Request For Information RFI-097

Subject: BP3 Art and Brand Wall Supplemental Steel
Project: Steamboat - BV BP Promenade and Goldwalk
Address: 2305 Mount Werner Circle
Steamboat Springs CO 80487 USA
Phone:
To: Bryan Sculthorpe
Saunders Construction, LLC
From: Saunders Construction, LLC

Subject: BP3 Art and Brand Wall Supplemental Steel
Project: Steamboat - BV BP Promenade and Goldwalk
Address: 2305 Mount Werner Circle
Steamboat Springs CO 80487 USA
Phone:
To: Stephen Carrola
Design Workshop Inc
From: Saunders Construction, LLC

1B-L7-03

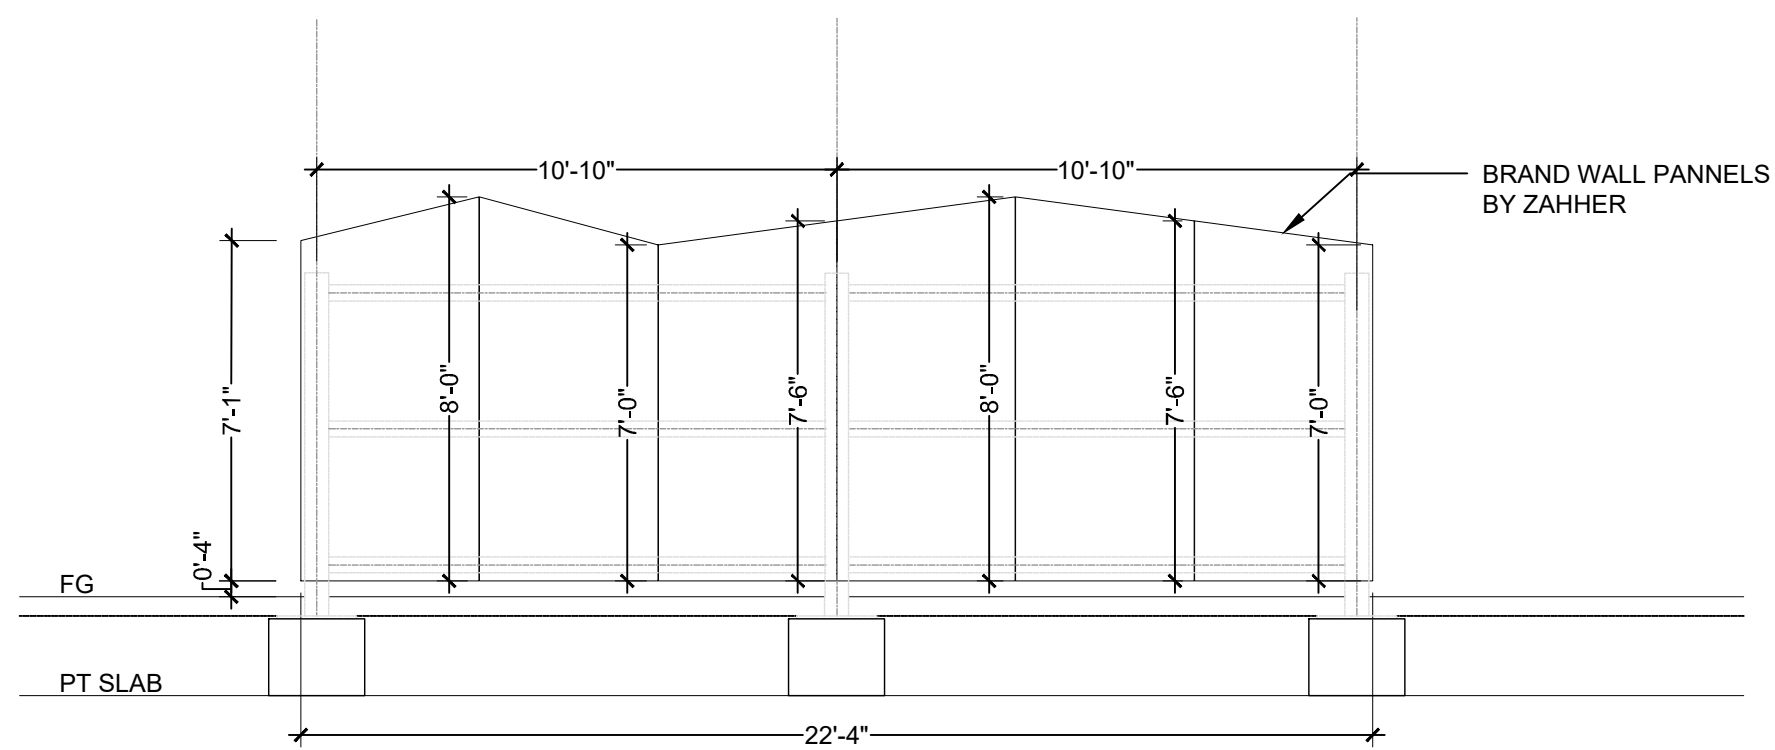
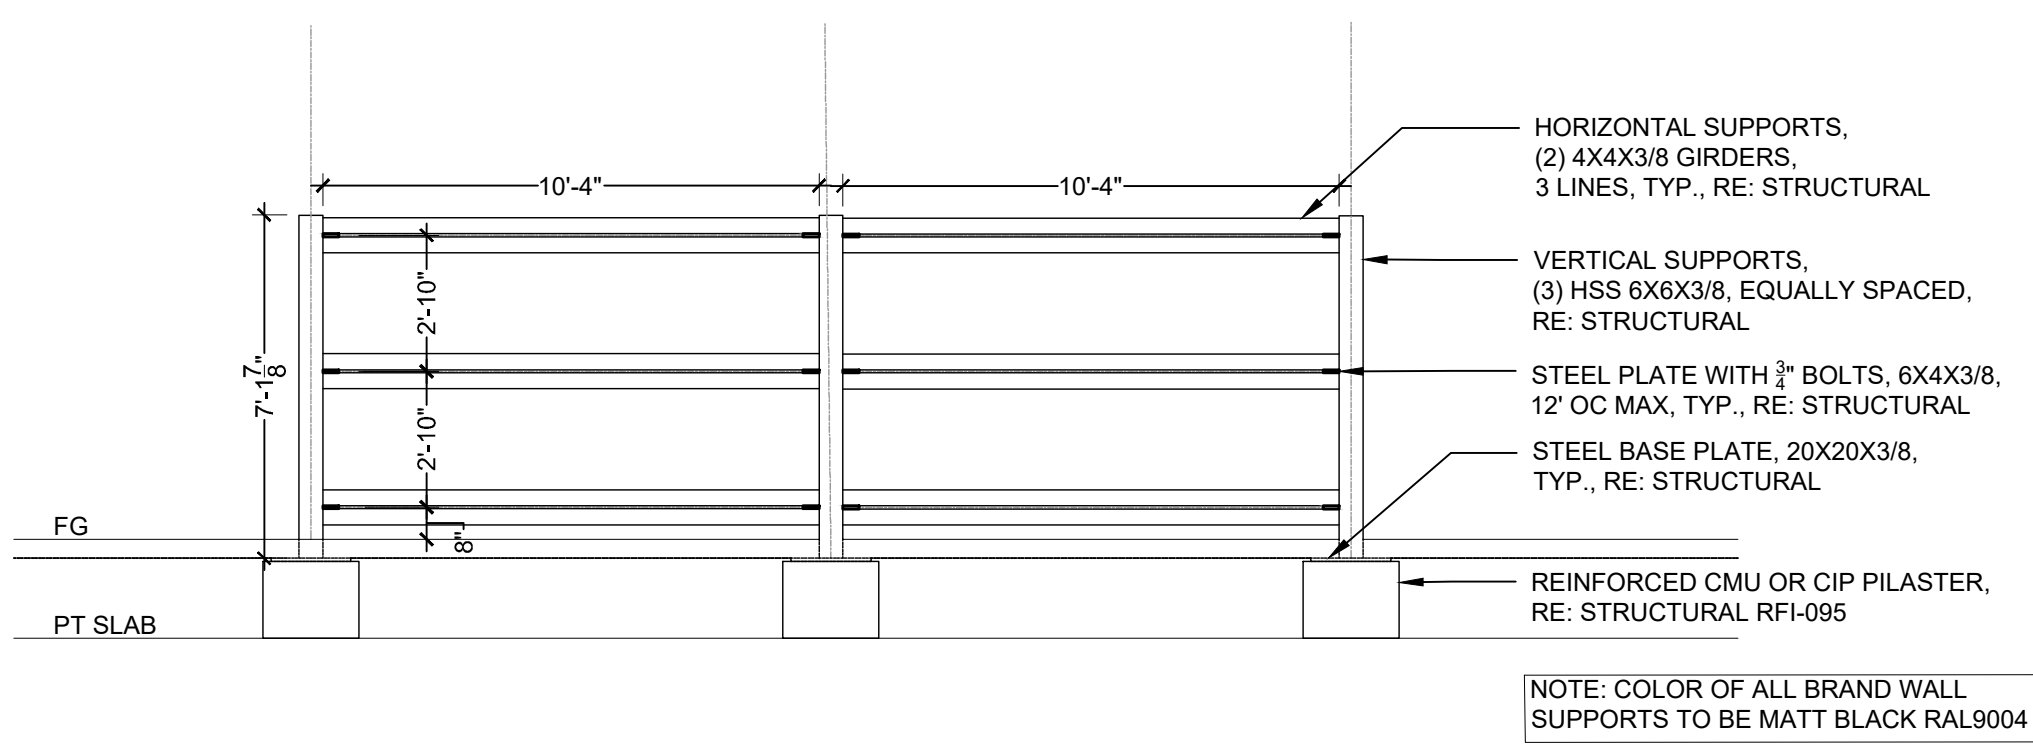
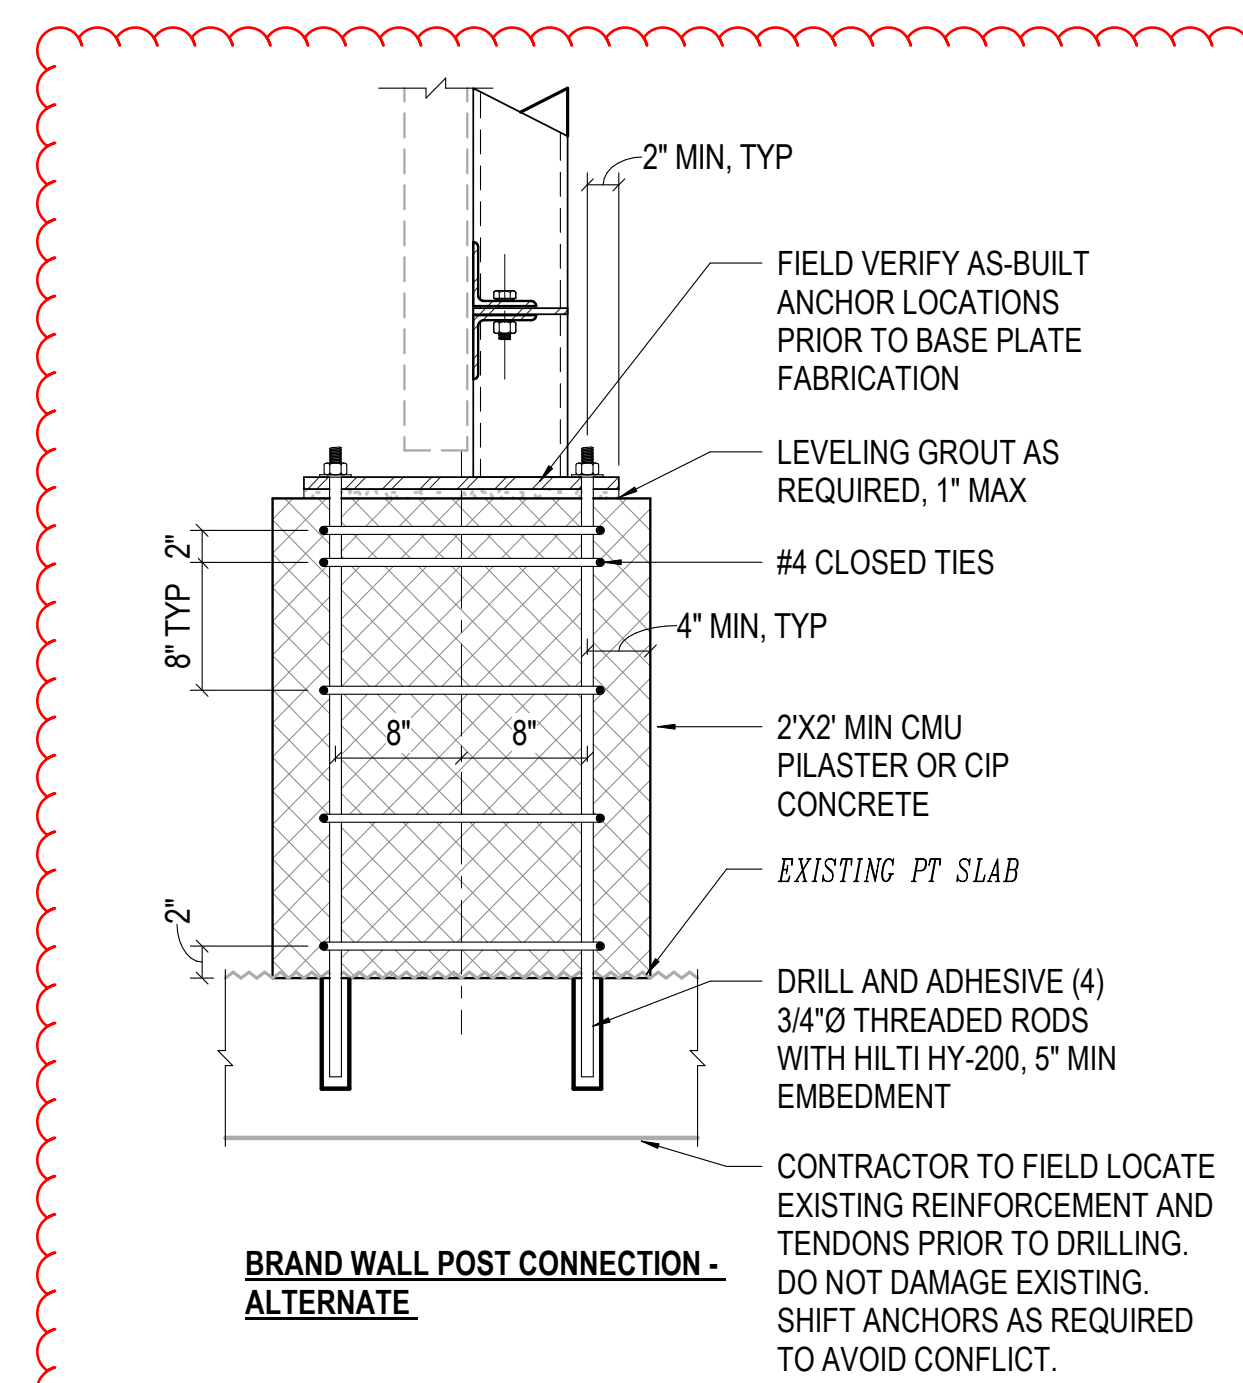
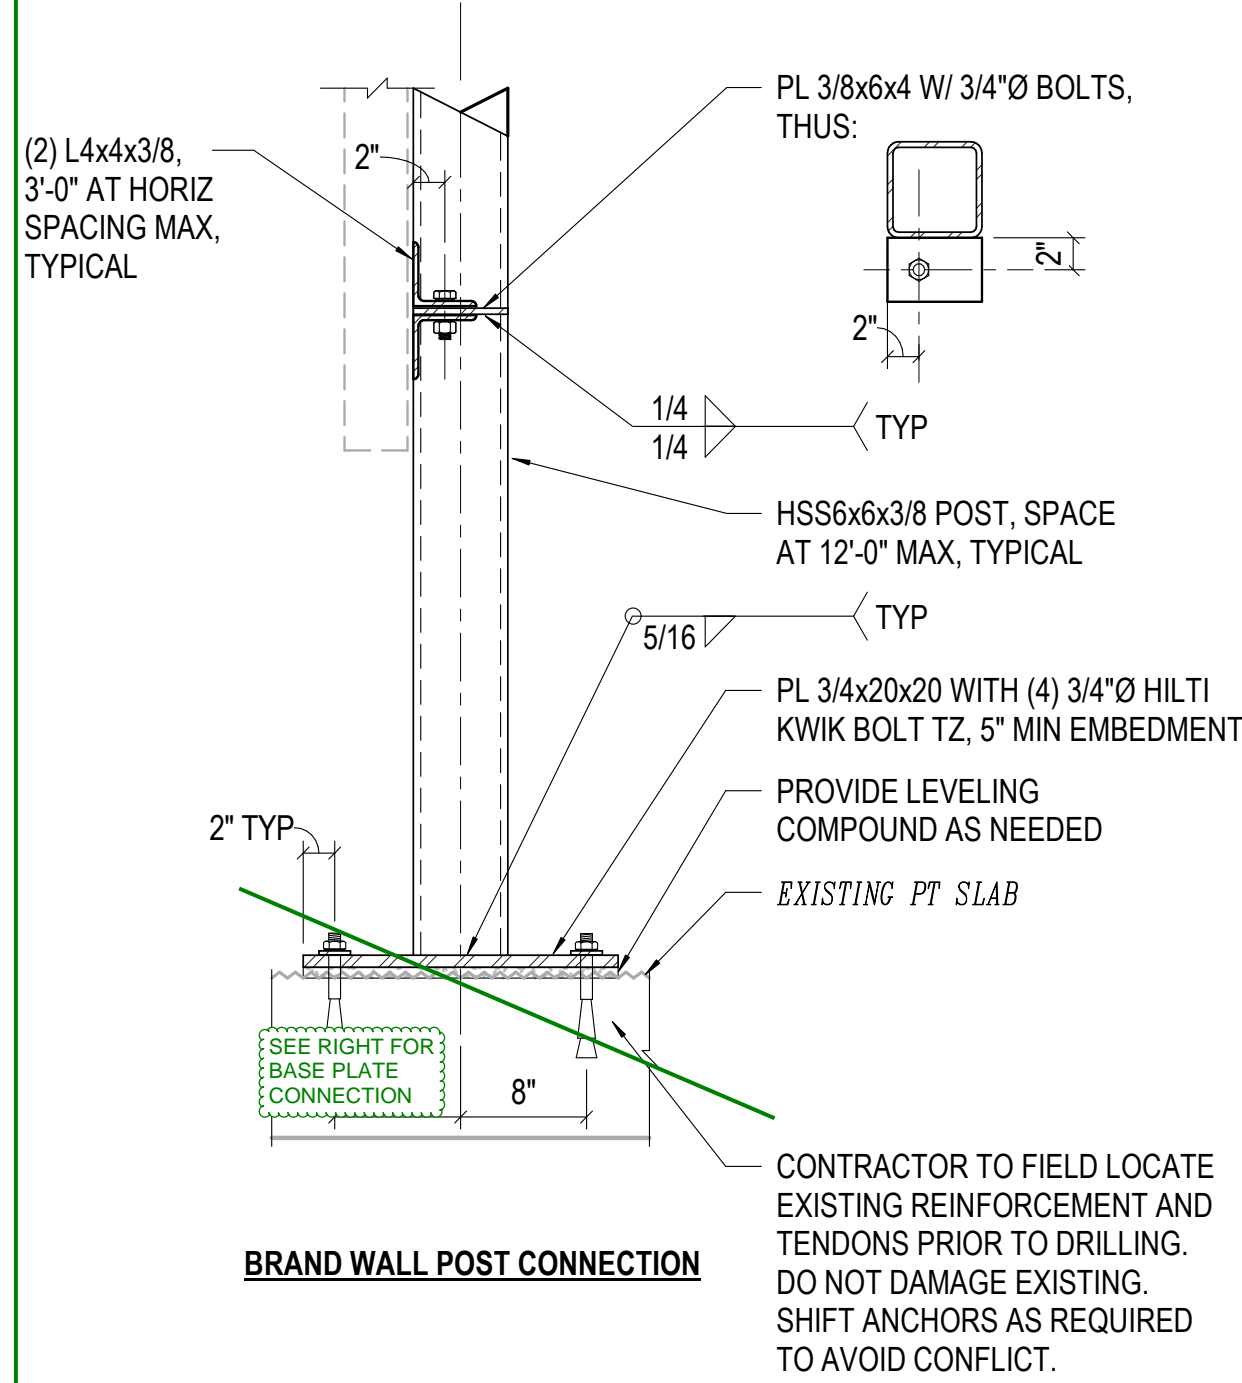
Ref attached correspondence and bootleg drawings sheets, the supplemental steel for the Goldwalk and Artwall is required to be included in BP3 Goldwalk scope.

Please confirm bootleg supplemental steel package should be included in scope. If so- please provide updated construction documents that are reflective of additional supplemental steel required.

DW HAS UPDATED OUR BP3 GOLDWALK DRAWINGS TO REFLECT THE REQUIRED SUPPLEMENTAL STEEL TO SUPPORT THE ART AND BRAND WALLS. ADDITIONALLY, WE HAVE UPDATED THE LIGHTING SCHEDULE AND LIGHTING PLAN TO INCLUDE THE F6 FIXTURES. REVISED DRAWINGS INCLUDE: L0-04 GENERAL INFORMATION, L3-01 MATERIALS PLAN, L4-01, L6-01 LIGHTING PLAN, L7-02 ART WALL DETAILS, L7-03 BRAND WALL DETAILS. SCARROLLA, DW, 10/01/21

GOLD WALK - LIGHTING PLAN - LEVEL 01

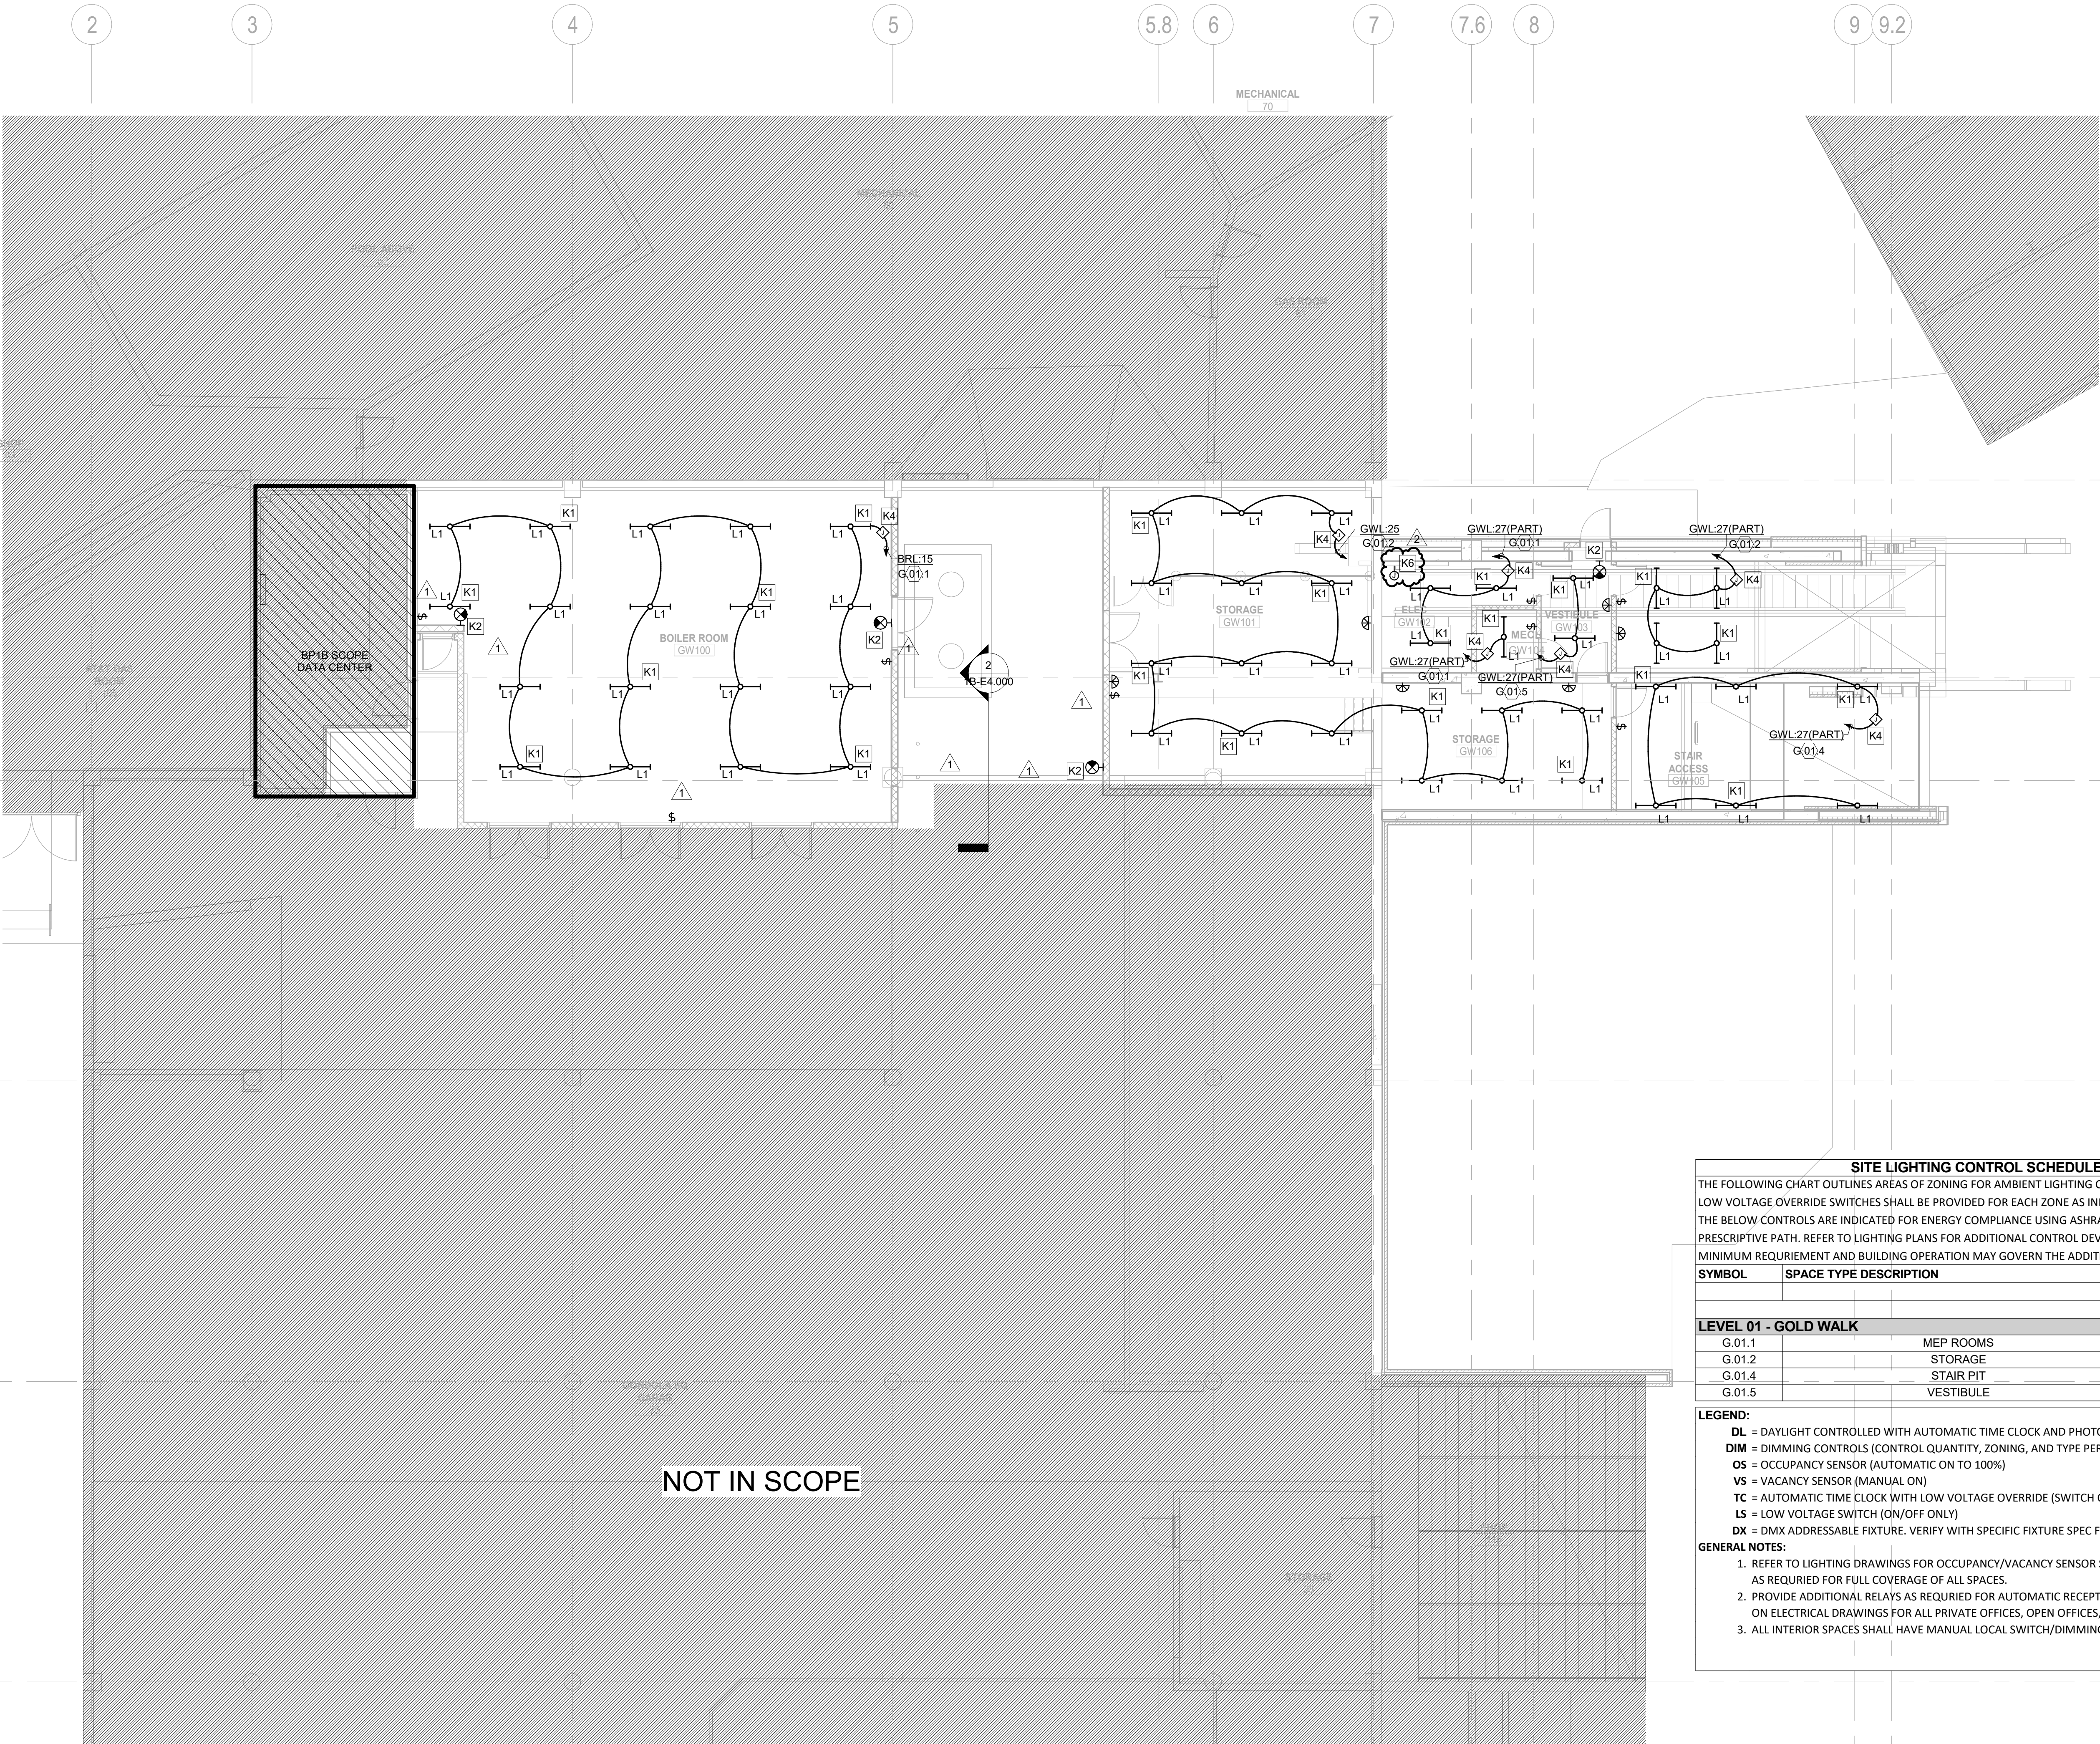
IN ADDITION TO THE STEEL QUESTION ABOVE, CIRCUITING AND CONTROL INFORMATION HAS BEEN PROVIDED IN THE ATTACHED DRAWING UPDATE FOR ADDED LIGHTING WITHIN THE ART WALL AND BRAND WALL. REFER TO ADDITIONAL CORRESPONDENCE (PAGES 7-21 HEREIN) FOR FIELD COORDINATION AND INSTALLATION CLARIFICATIONS.

- K6 POWER SUPPLY AND DATA INJECTOR ASSOCIATED WITH F6 LIGHT FIXTURE AT ART WALL AND BRAND WALL TO BE LOCATED IN ACCESSIBLE LOCATION WITHIN THIS ROOM. REFER TO SITE LIGHTING PLAN AND LIGHTING DESIGNER PLANS FOR ADDITIONAL INFORMATION.

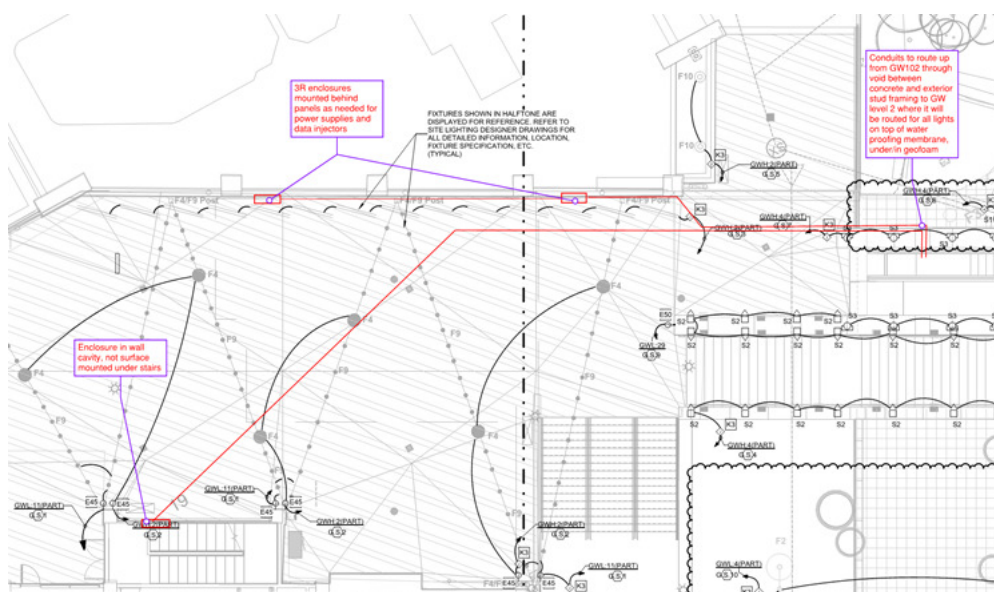
See snippet for proposed conduit routing if possible to keep electrical equipment in GW102. Thanks for sharing the desired effects conversation, I will pass this along to TLA and see if this is possible with our current BOM. It sounds like these effects should be basic enough. Let me know if our theory on cable lengths stands true, and we will build towards that.
